HISTORIC AND DESIGN REVIEW COMMISSION

HDRC CASE NO: 2025-090
ADDRESS: 910 E SOUTHCROSS BLVD
LEGAL DESCRIPTION: NCB 7665 LOT SW 200 OF 4 & NE IRR 118.4 OF SW IRR 233. 4 OF C & W IRR 93 OF 15
ZONING: I-1
CITY COUNCIL DIST.: 3
DISTRICT: Mission Historic District
APPLICANT: Edward Hernandez/Nirvana Architecture Studio
OWNER: Isarael Ramirez/LIDS CHRISTIAN CENTER INC
TYPE OF WORK: Final Approval - New Construction of 10,000 sf church
APPLICATION RECEIVED: April 9, 2025
60-DAY REVIEW: June 8, 2025
CASE MANAGER: Caitlin Brown-Clancy

The applicant is requesting a Certificate of Appropriateness for approval to construct a new 10,000 sf building housing an auditorium, classrooms, and various auxiliary spaces on the existing campus of LIDS Christian Center at 910 E Southcross Blvd and site work consisting of a master parking and landscaping plan.

1 SITE PLAN

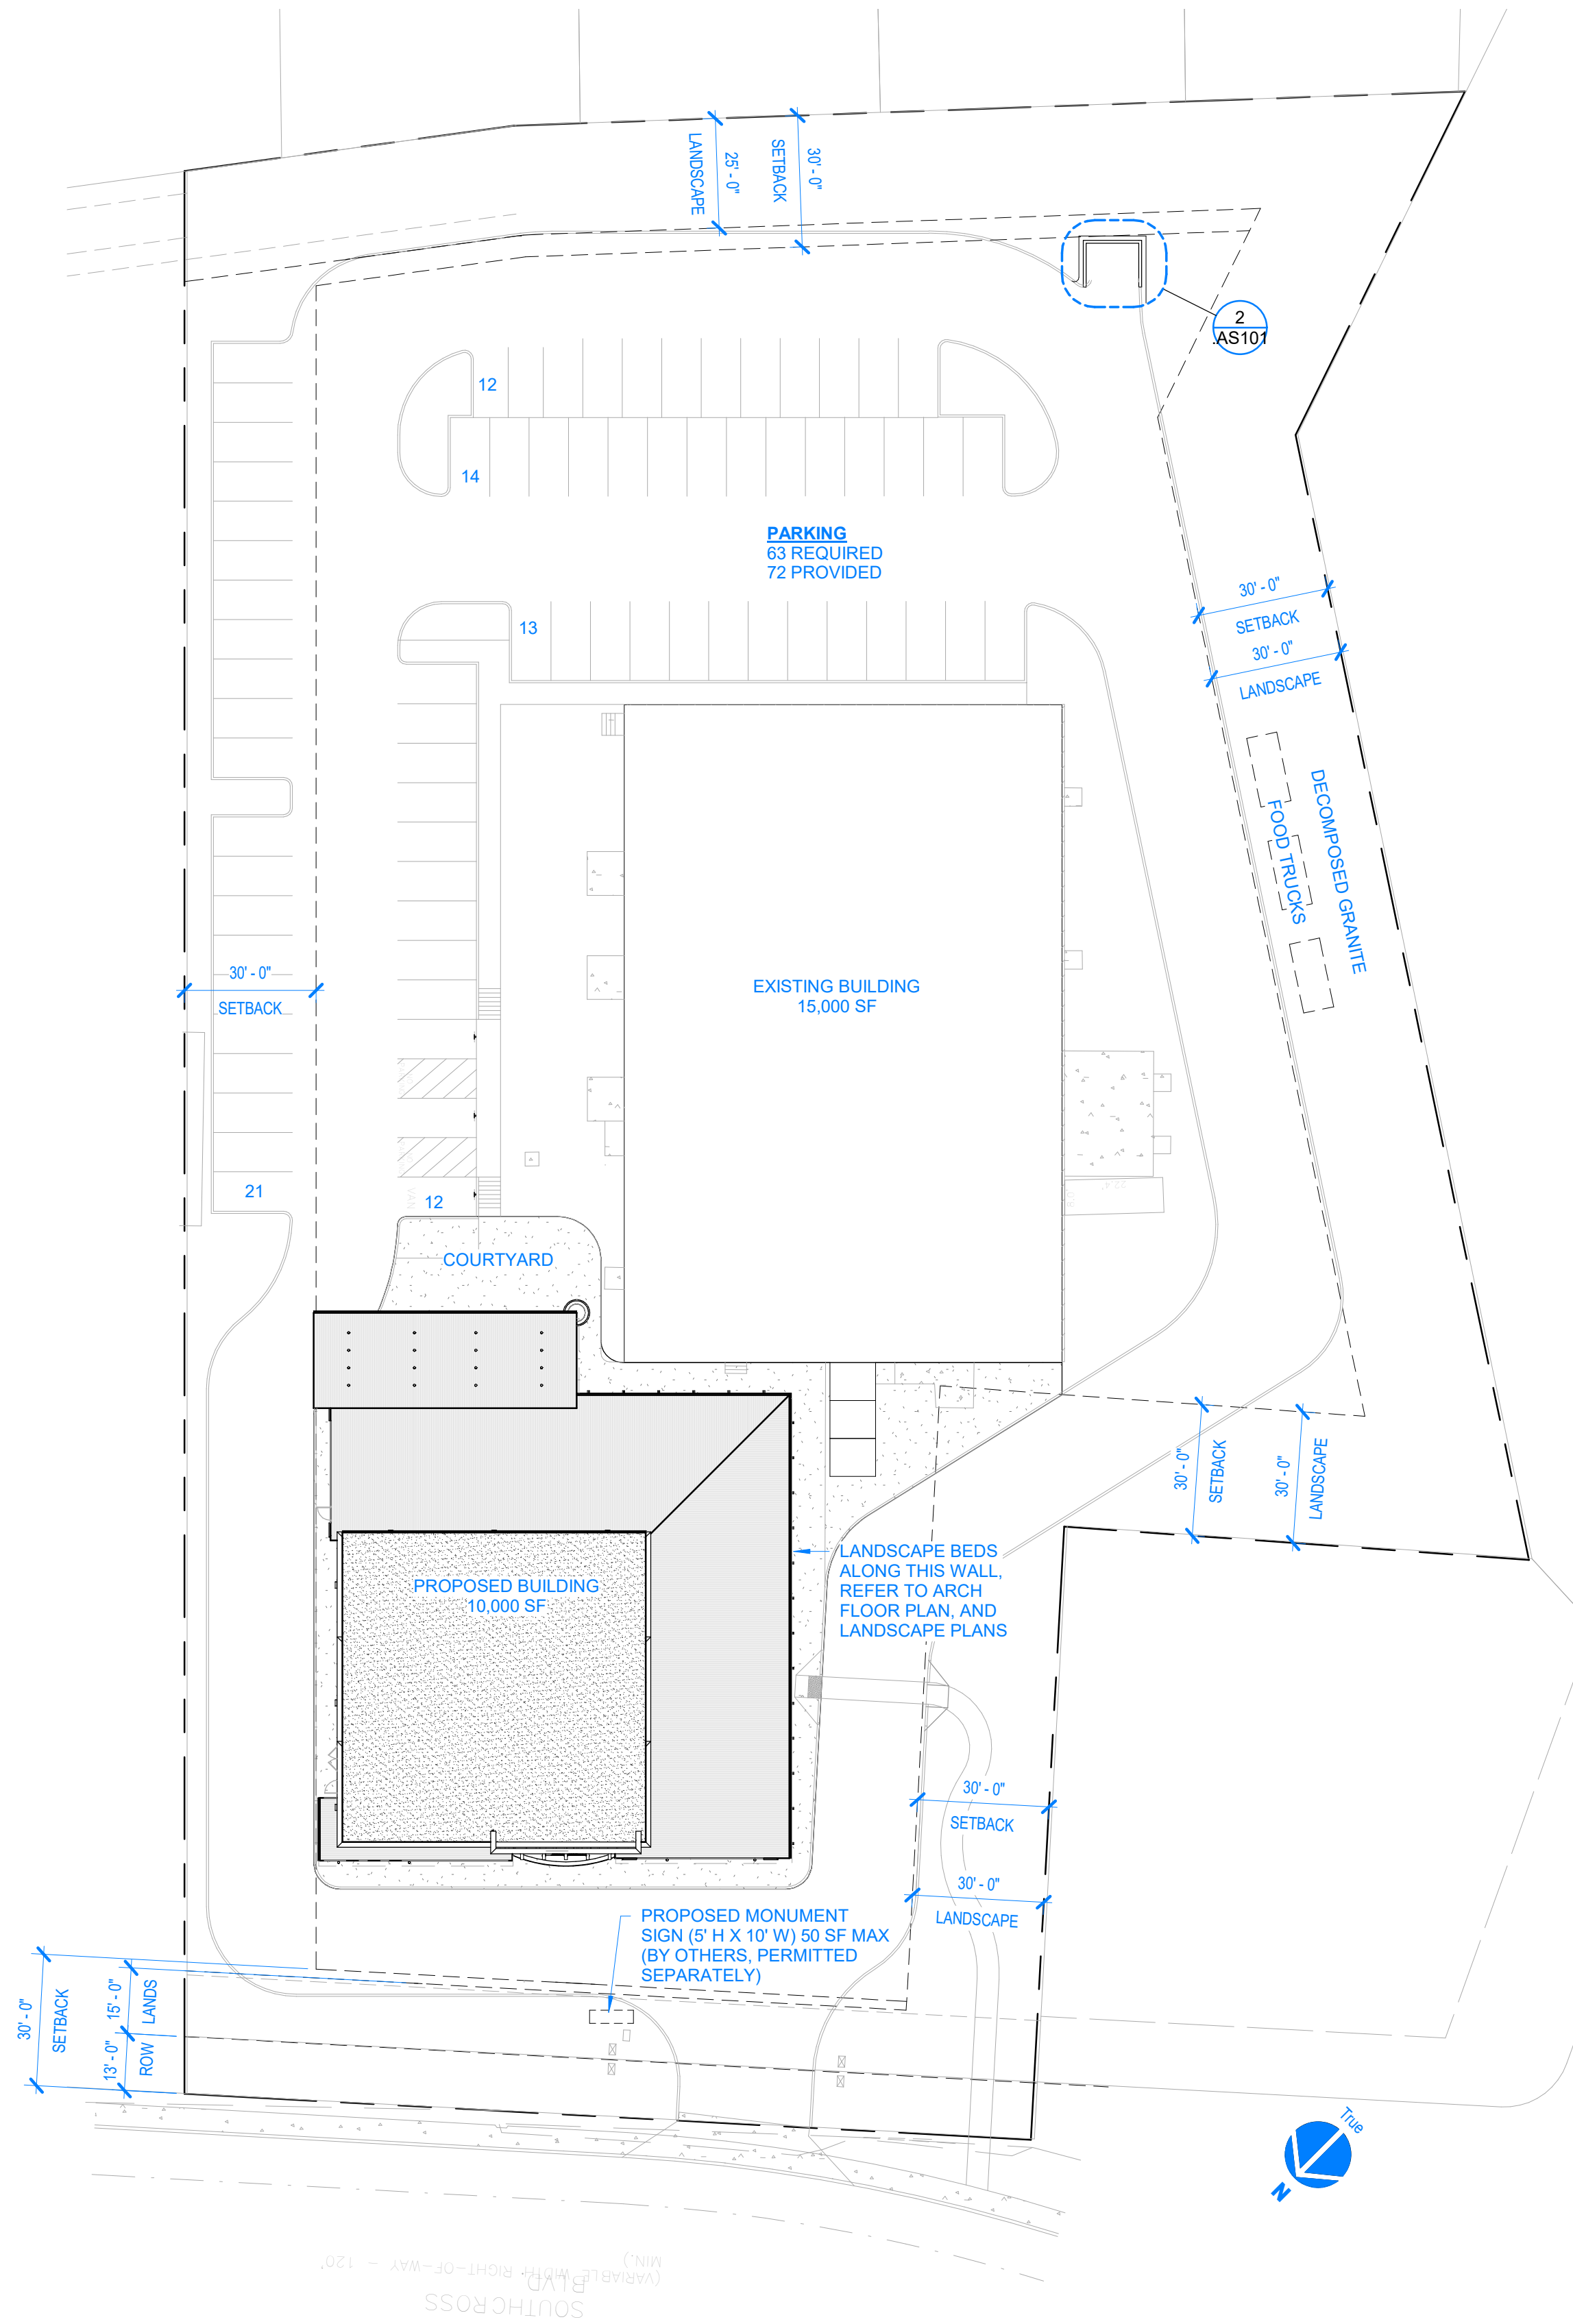
- f. **SITE DEVELOPMENT (SETBACK)** – The applicant has not indicated the exact setback depth, however, plans indicate a set back of approx. 60’0”. Guideline 3.A.v states that on corridors where building setbacks vary or are not well-defined by existing contributing buildings, buildings should maintain a minimum front setback of 15’ for properties north of SE Military. Staff finds the applicant should submit a dimensioned site plan indicating all setbacks prior to returning to the HRDC for final approval.

- g. **SITE DEVELOPMENT (PARKING)** – The applicant is requesting to introduce parking at the rear and Eastern side of the lot which accommodates 72 spaces. Guideline 3.A.vi states that Rear / side parking is encouraged north of SE Military Drive. Staff find the proposed parking plan appropriate.

- h. **SITE DEVELOPMENT (VEHICULAR ACCESS)** – The applicant has proposed one main driveway into the property that splits into two that circumnavigate the existing and new structures leading to the rear parking lot. Currently, the applicant has not indicated the width of the proposed drive and approach. Guideline 3.A.vii states that, in general, driveway widths should not exceed 24’. Staff finds the applicant should submit a dimensioned site plan indicating driveway and approach dimensions prior to returning to the HRDC for final approval.

- n. **LANDSCAPE** – The applicant has submitted a conceptual landscaping plan that features a 30'0" wide landscaping buffer on the N, S, and W property lines to include unspecified trees, low plantings, and decomposed granite. Additionally, the site features a few water features at the new construction and unspecified trees throughout the parking lot. Guideline 3.V.iii calls for parking areas to be screened from the sidewalk and street with landscaping to allow a filtered view of the parking area while reducing its overall visual impact. Additionally, Guideline 3.v.i states that canopy trees shall be integrated into the design of surface parking lots to provide shade for a minimum of 25 percent of any individual parking lot. Generally, staff finds the proposed landscaping plan to be appropriate but finds the applicant should submit a final landscaping plan indicating plant and tree species and material specifications that are consistent with the Guideline for review prior to returning to the HDRC for final approval.

Staff recommends approval to construct a new 10,000 sf building housing an auditorium, classrooms, and various auxiliary spaces on the existing campus of LIDS Christian Center at 910 E Southcross Blvd and site work consisting of a master parking and landscaping plan with the following stipulation;
